**ETS 300 347-1**  
pr **A1**

**This draft amendment A1, if approved, will modify  
the European Telecommunication Standard ETS 300 347-1 (1994)**

**Signalling Protocols and Switching (SPS);  
V interfaces at the digital Local Exchange (LE);  
V5.2 interface for support of Access Network (AN);  
Part 1: V5.2 interface specification**

**Figure 11: Link control functional model**

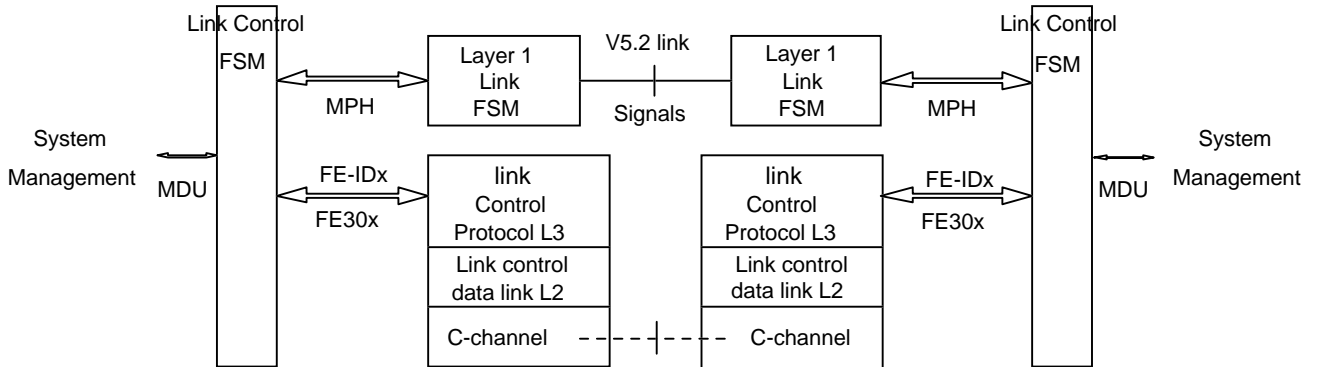
- Clause 16, figure 11: The invisible text is reconstituted from an earlier version.
- Subclause 16.2.4.5: A note is added about the sending of a notification to system management.

Add the formerly "invisible" text to figure 11:

Figure F.1: A possible AN/LE configuration using the V5 standard

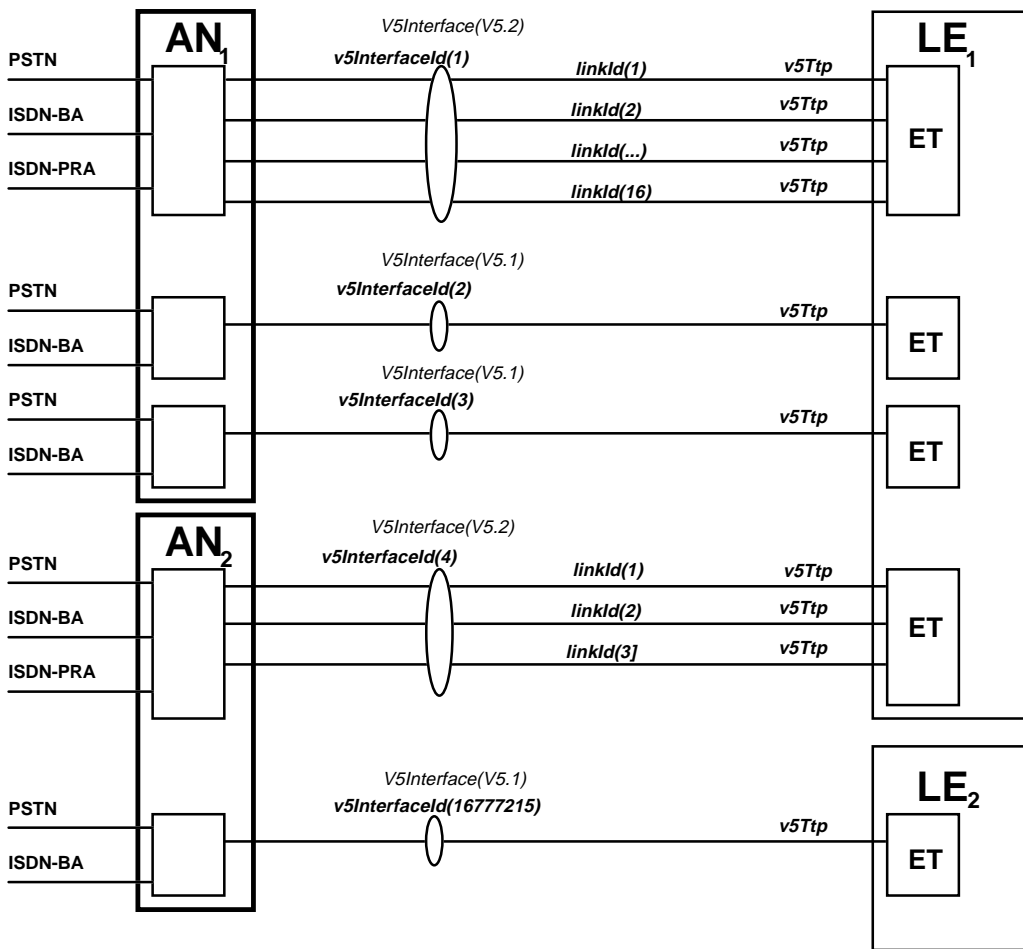
Figure F.1 shows one case with two LEs and two ANs connected to each other via five V5 interfaces with the following given v5Interfaceld values: 1, 2, 3, 4, up to 2<sup>24</sup>-1, 16777215). LE<sub>1</sub> is connected to AN<sub>1</sub> and AN<sub>2</sub> using V5 interfaces of type both V5.1 and V5.2 to the same AN. Both LE<sub>1</sub> and LE<sub>2</sub> are connected to AN<sub>2</sub> using separate V5 interfaces of different types.

**Page 163, figure L.6**

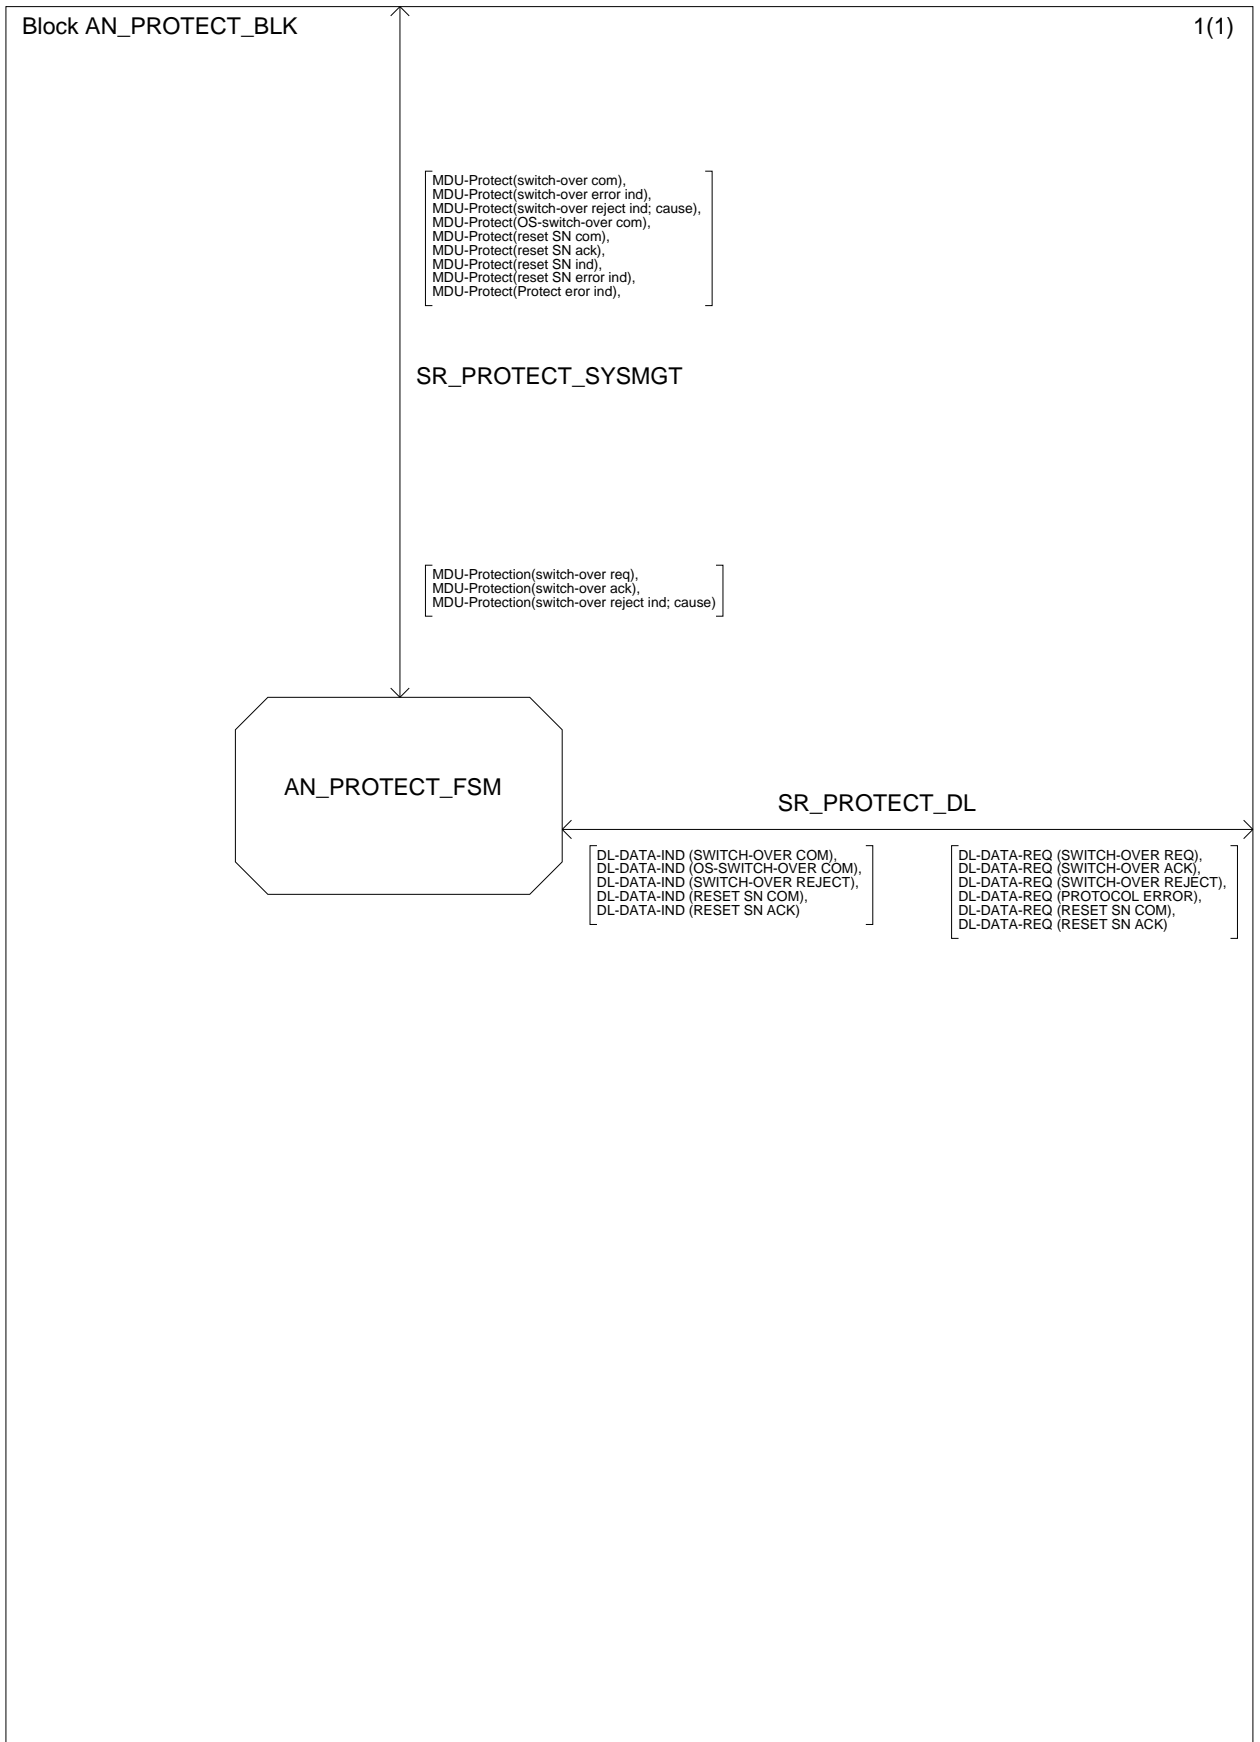
- Annex L, figure L.6: Some MDU-Protection primitives are missing for SR\_PROTECT\_SYSMGT: reset SN com, reset SN ind, reset SN ack and Protocol error indication.

Replace all prefixes of primitives for system management "MDU-Protection" by "MDU-Protect".

Replace "MDU-Protect(switch-over reject; cause)" by "MDU-Protect(switch-over reject ind; cause)".

Add the following MDU-Protection primitives for signal route SR\_PROTECT\_SYSMGT, upper signal list: OS-switch-over com, reset SN com, reset SN ack, reset SN ind, reset SN error ind and Protocol error ind.

Add the following PDU for signal route SR\_PROTECT\_DL, right signal list: PROTOCOL ERROR.

Page 194, figure L.13.4

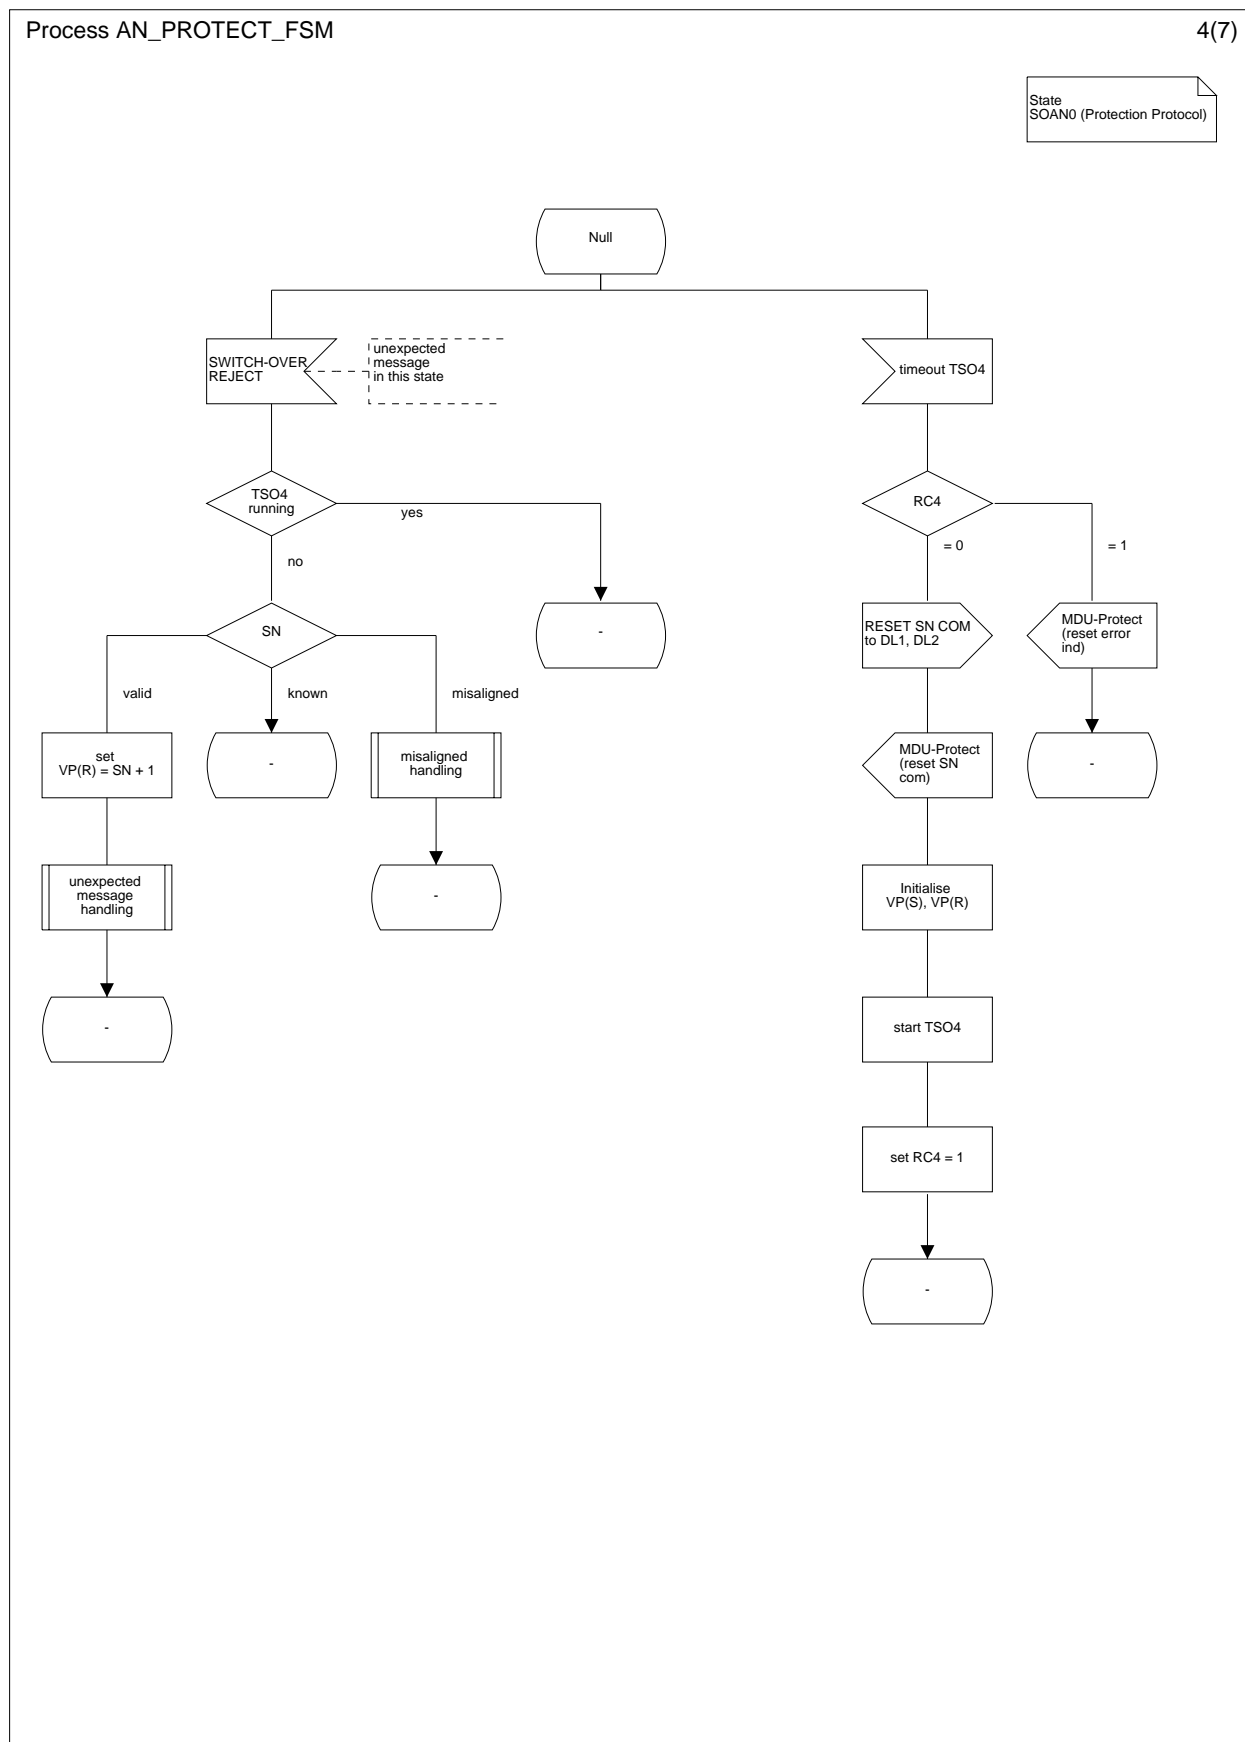
- Amendment: Both figures L.13.4 and L.36.4 are corrected with a task symbol to initialize VP(S) and V(P) before start of TSO4.
- Annex L, figure L.36.5: A stop of timer TSO2 is missing in the bottom left branch.

Add the task symbol "initialize VP(S), VP(R)" before task symbol "start TSO4".

Page 200, figure L.15.2

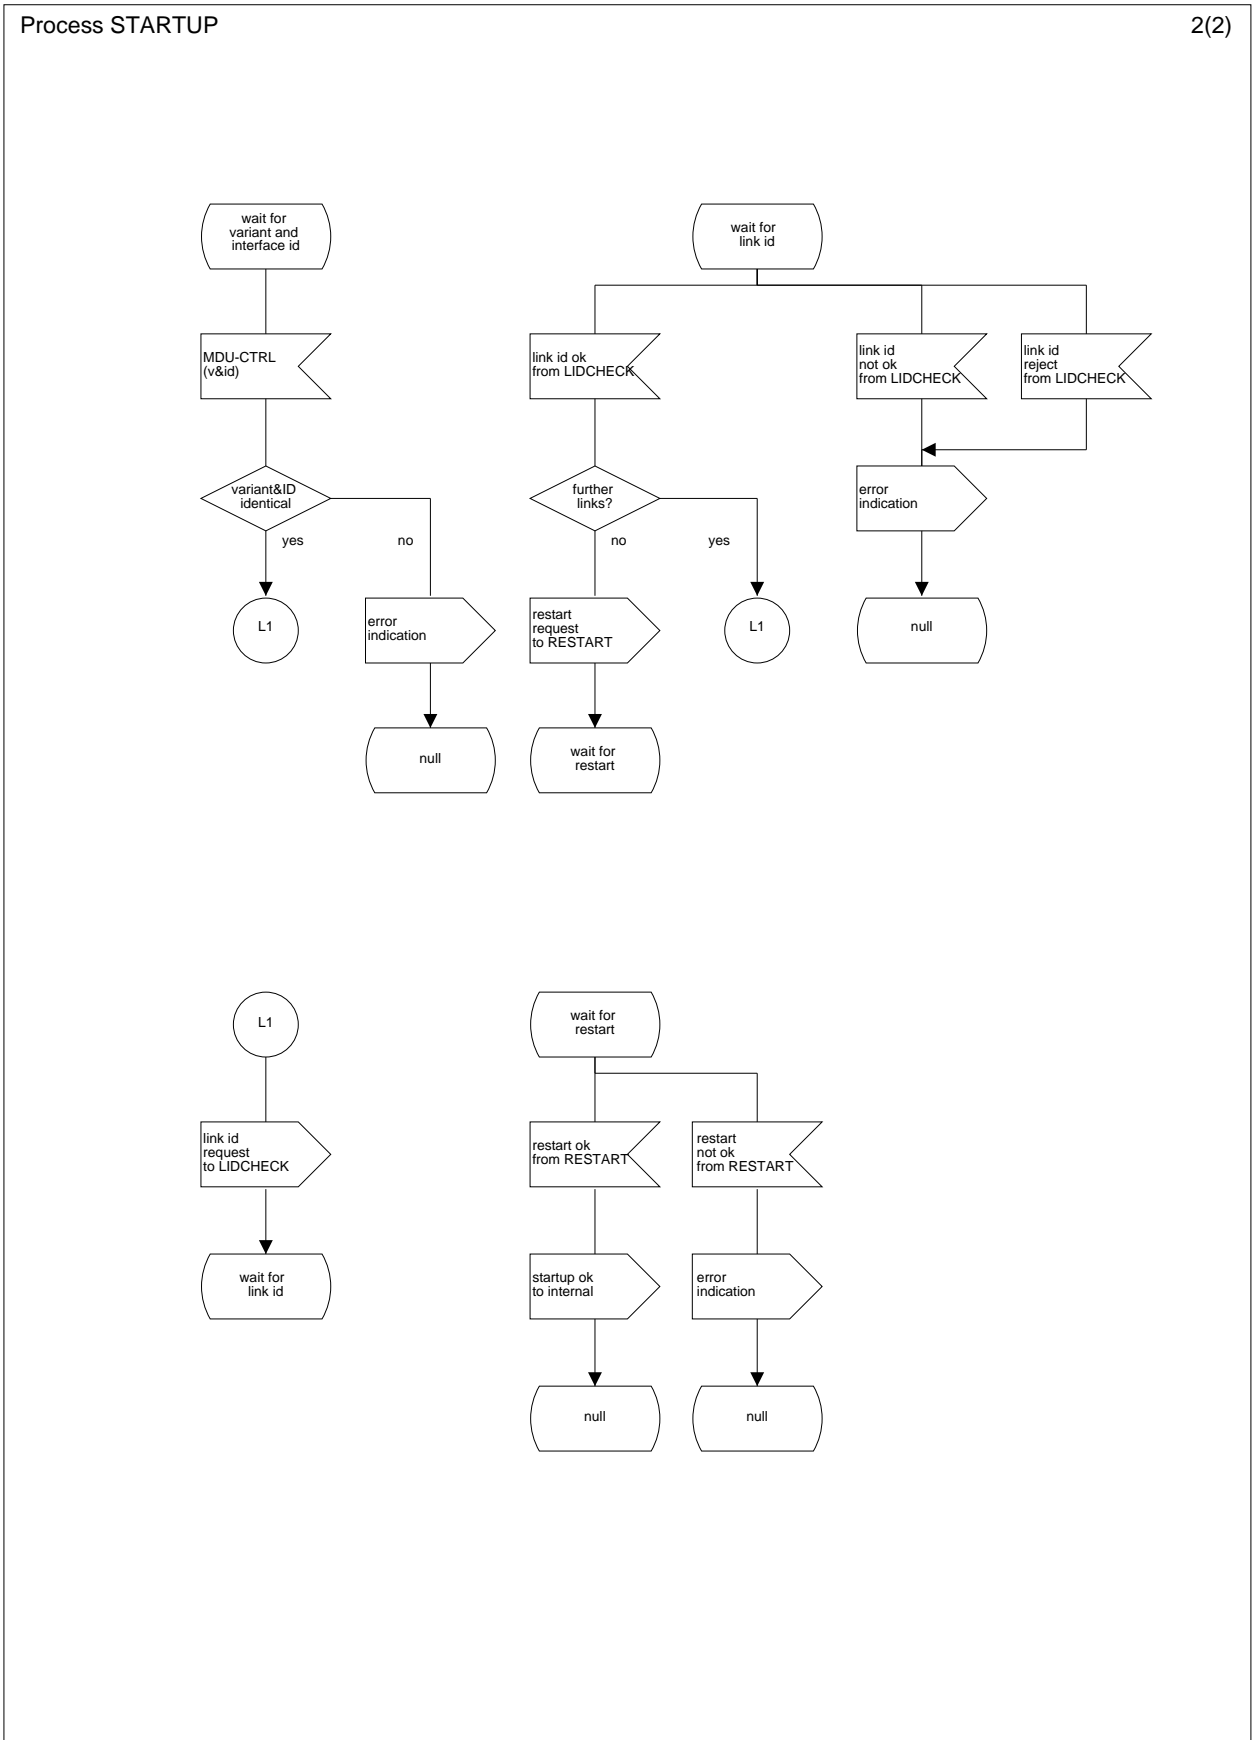
Annex L, figure L.15.2: Figure L.15.2 is contradictory to annex C, item 13), which requires that the variant and interface ID shall be checked during system start-up. Figure L.15.2 shows only a check of the interface ID.

Amendment: Update the figure by adding a decision for the correct variant.

Replace decision "ID identical" by "variant&interface ID identical".

Page 205, figure L.18.1

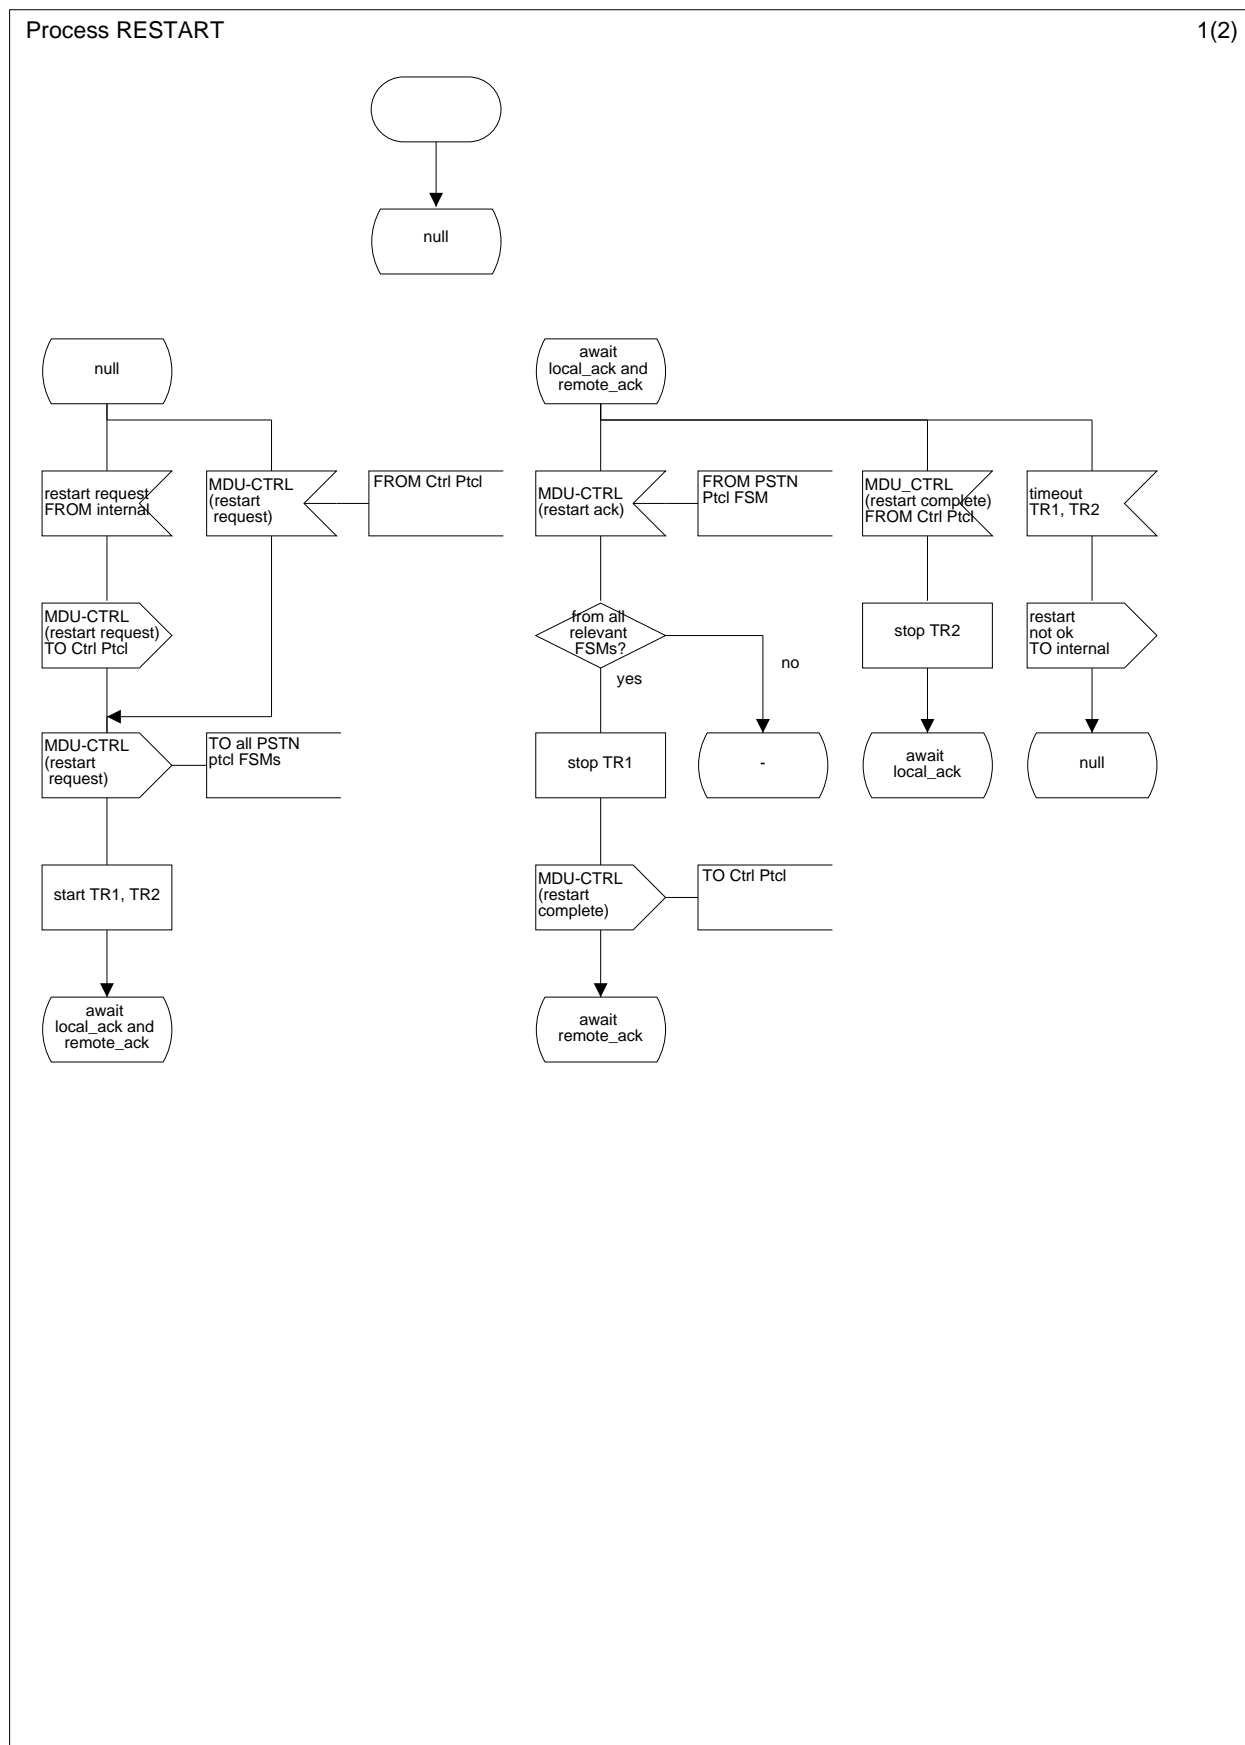
Replace the complete figure.
